RFI

RFI #: 87
 Date: 3/27/2012
 Job: EB-02 Keller Springs Lofts
 Phone: 877-777-5115

CC: Erik Earnshaw (Beeler Guest Owens Architects)
 Subject: Brick Ledge at 10" Drop in Slab

RFI #: 169
 Date: 7/9/2012
 Job: EB-02 Keller Springs Lofts
 Phone: 877-777-5115

Drawing: A3.1B & A3.1D
 Cost Impact: None

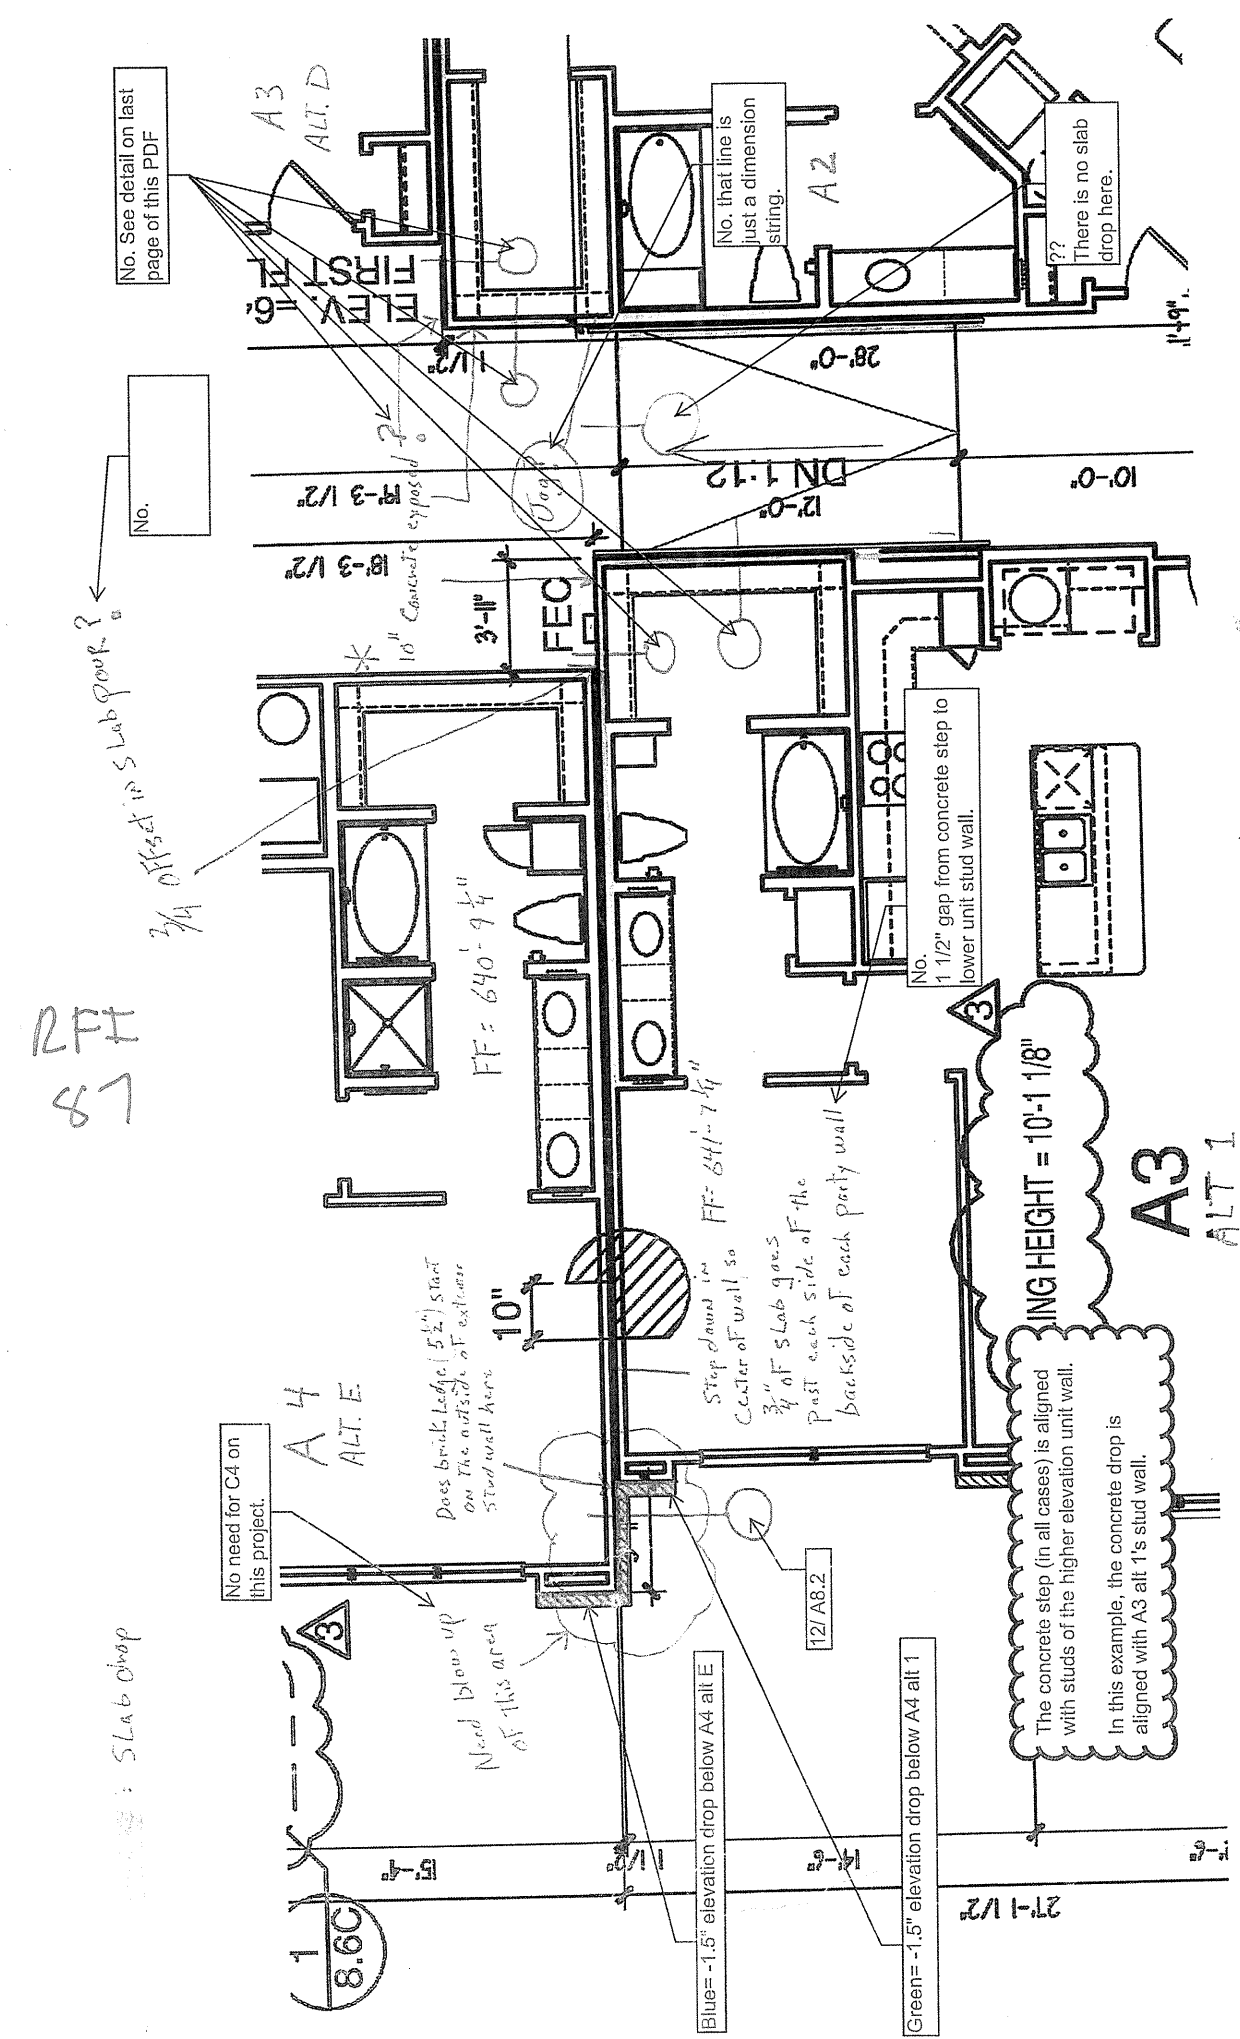
Request:
 1. Please confirm that the ceiling height of the A1 unit (#1118) is 10'-11 1/8". Sheet A3.1A shows it to be that measurement, but A3.1B shows it to be something else.
 2. Please confirm ceiling heights of the A4 units on A3.1D. Shouldn't they be 10'-1 1/8"?
 3. Please confirm the ceiling height of the A2 units on A3.1D. One has 10'-1 1/8" and I think it should be 10'-7 1/8".

Response:
 1. drawing A3.1A is correct, and A3.1B is incorrect.
 2&3 on sheet A3.1D, starting with the ceiling height of unit A3 on the far right facing the pool courtyard= 10' - 1 1/8", going clockwise around the courtyard from there we get
 A3= 10'- 1 1/8" (no change, but when you see *** that means change)
 A2= 10'- 7 1/8" due to drop in foundation
 A2= 10'- 7 1/8" ***
 A4= 10'- 1 1/8" because we step back up in the foundation
 A4= 10'- 1 1/8" ***

3.1B

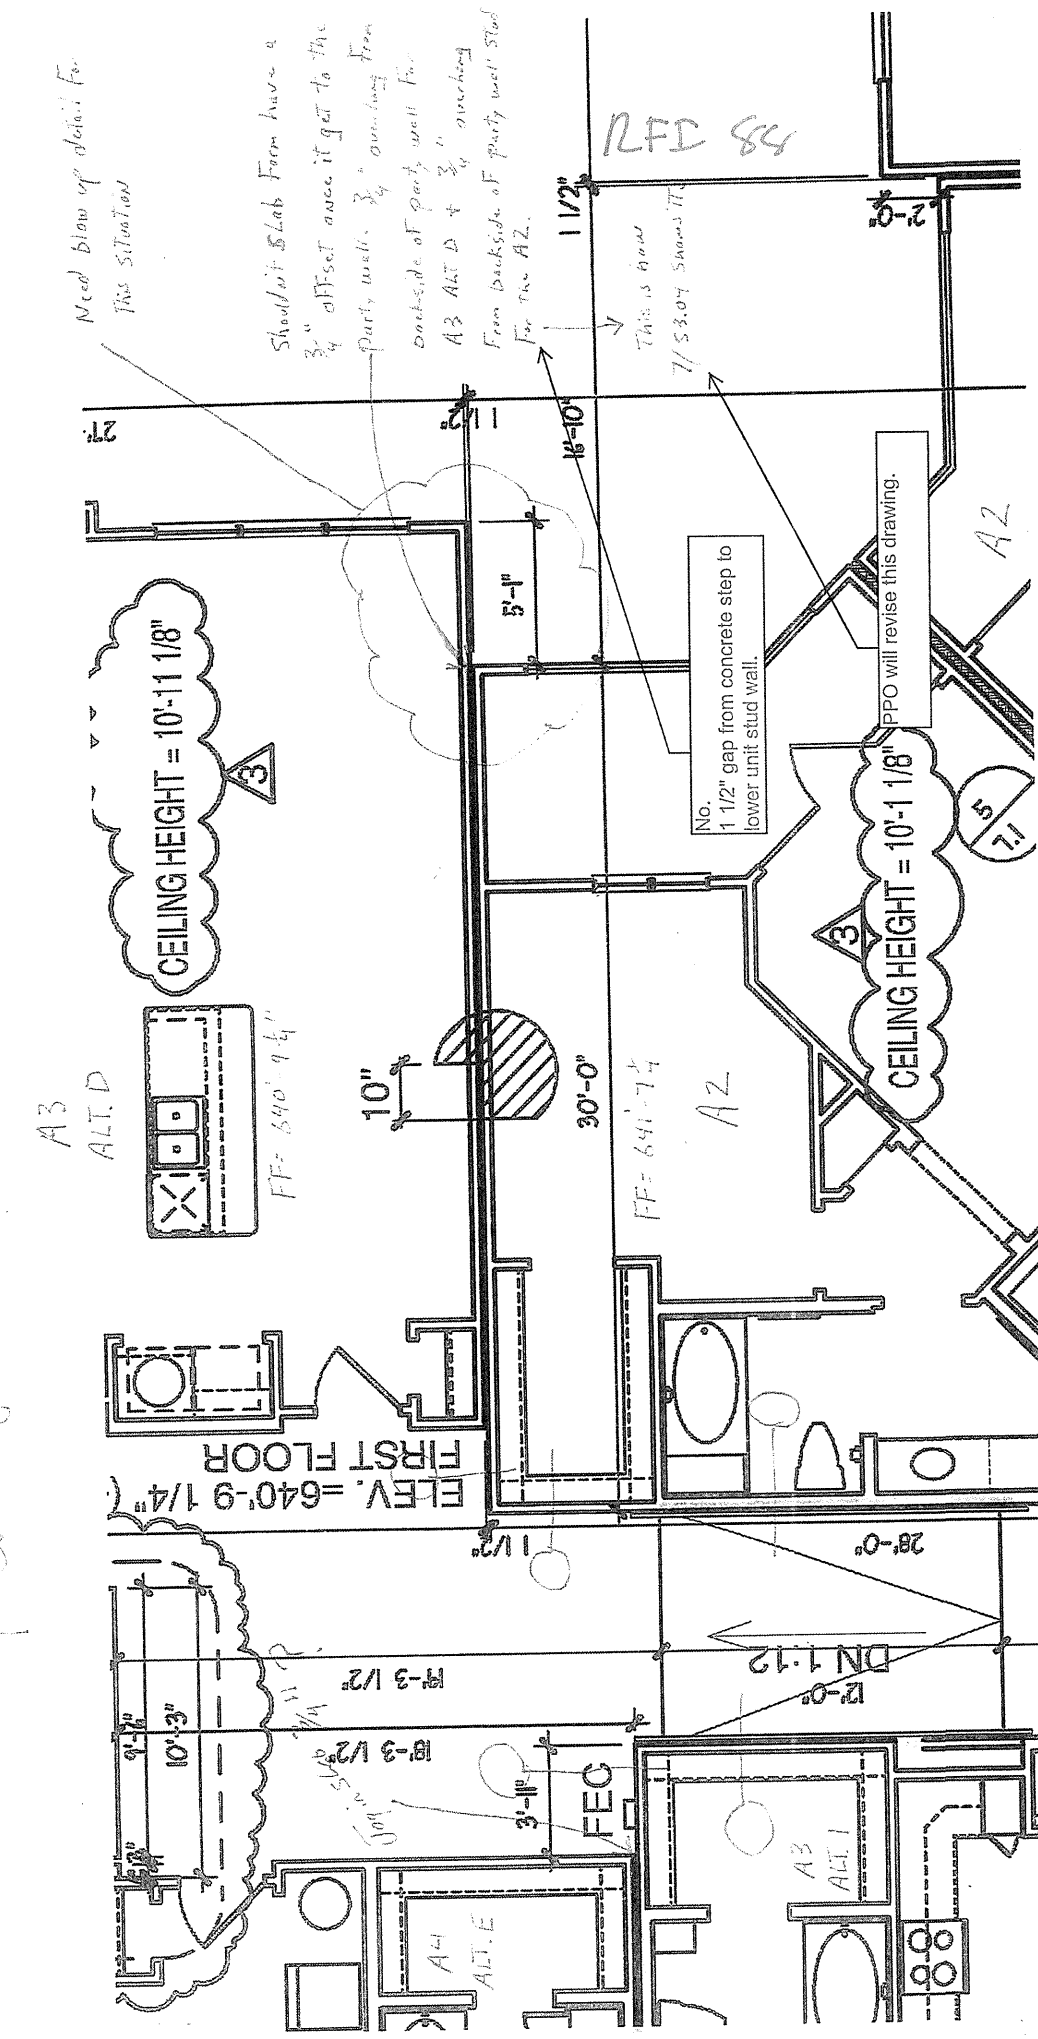
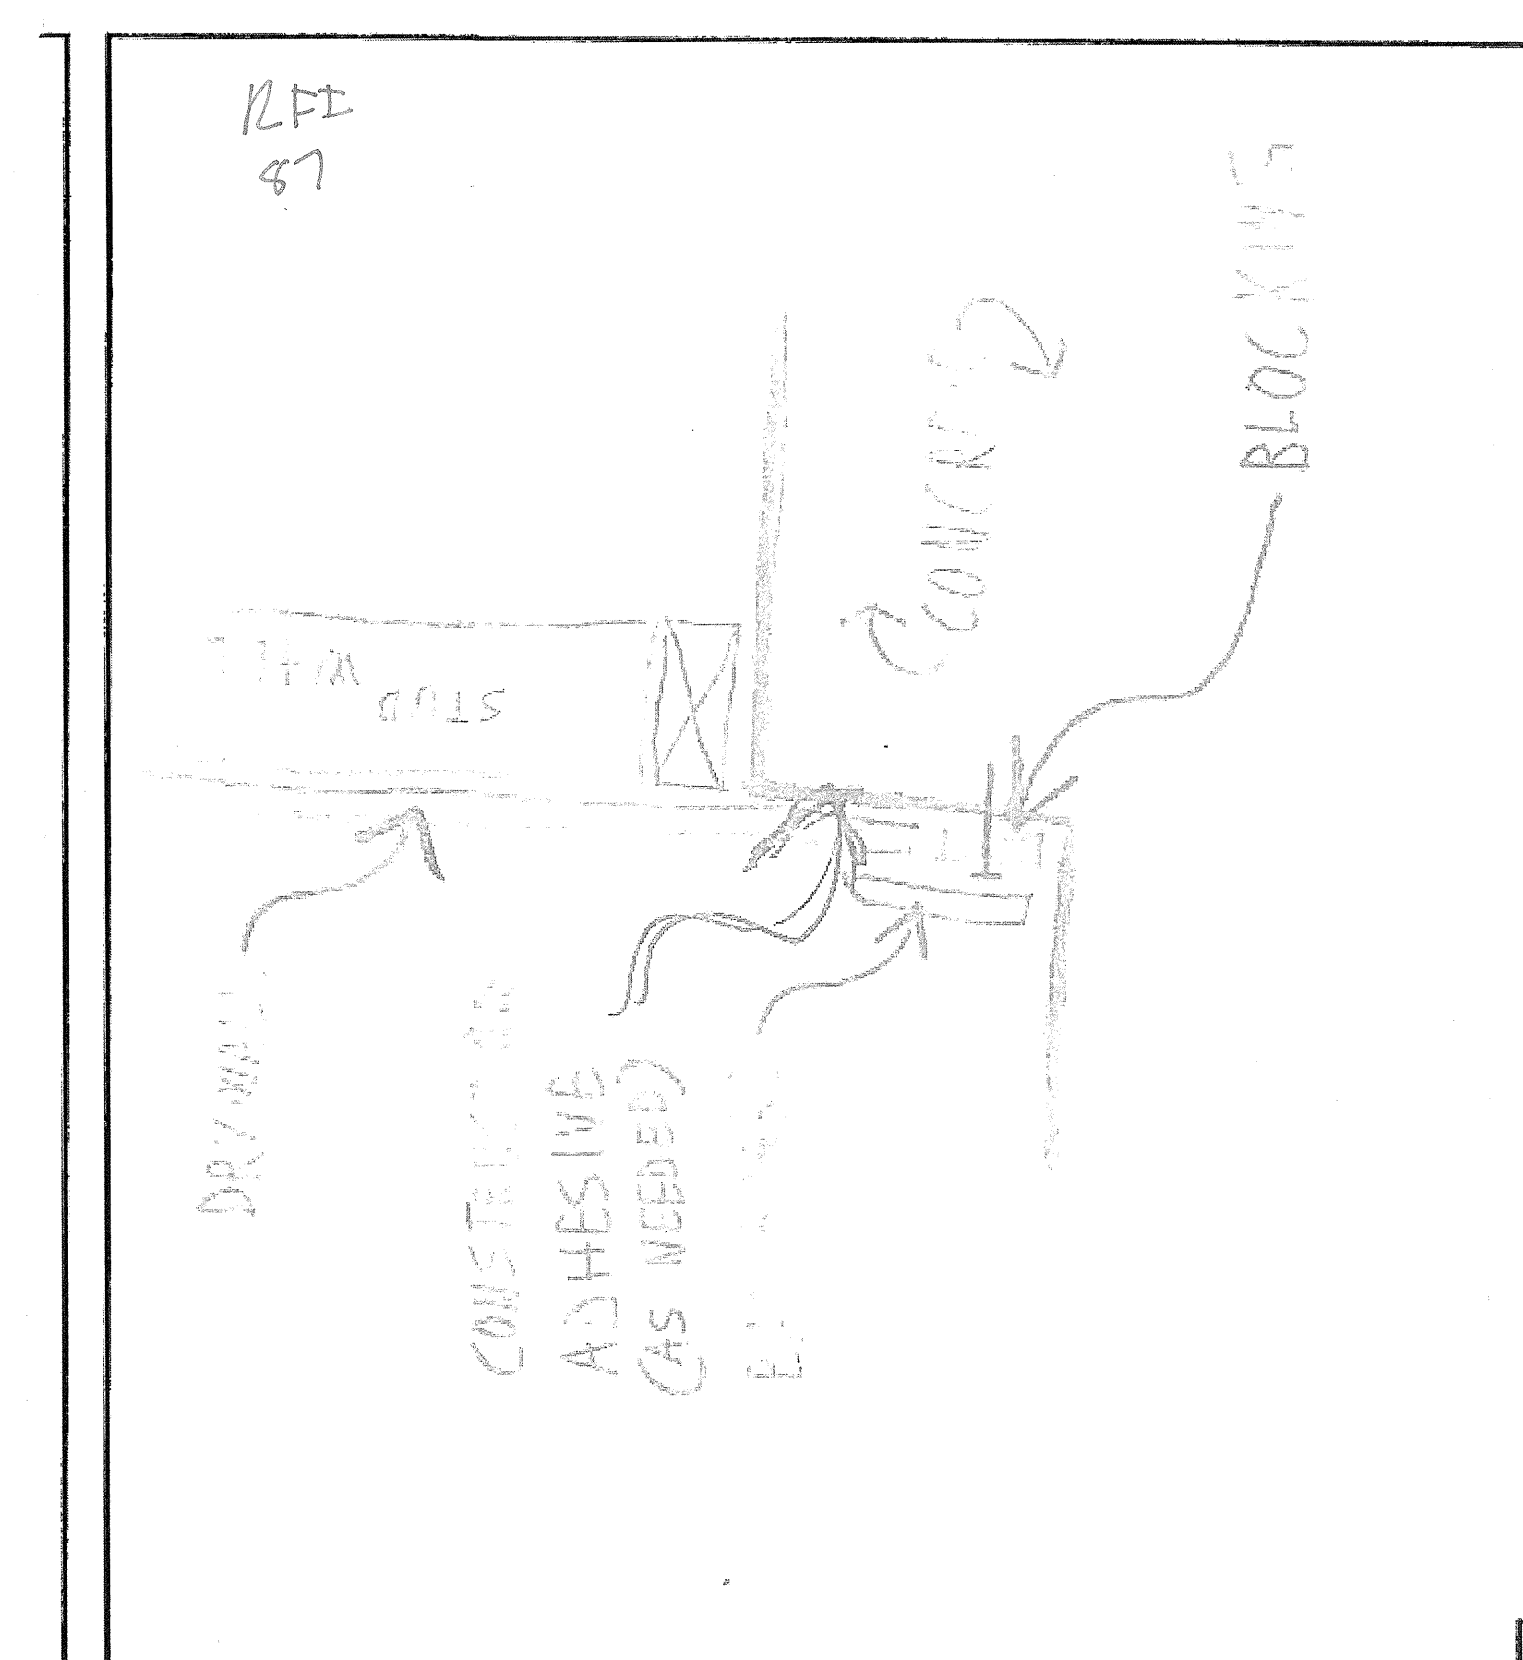
Request:
 See the attached drawings. The walls shaded in purple show where the slab drops. There will be exposed concrete in certain areas. We would like to see the following:
 1. Typical cuts in the areas indicated showing how to finish the bottom of the wall.
 2. A blow up detail showing the area on the right side in the corner where the two slabs are at a different elevation.

6 = Cut Through elevations Needed

Response:
 Half of these questions are answered in RFI-087.
 See the next pages for remaining answers/comments.
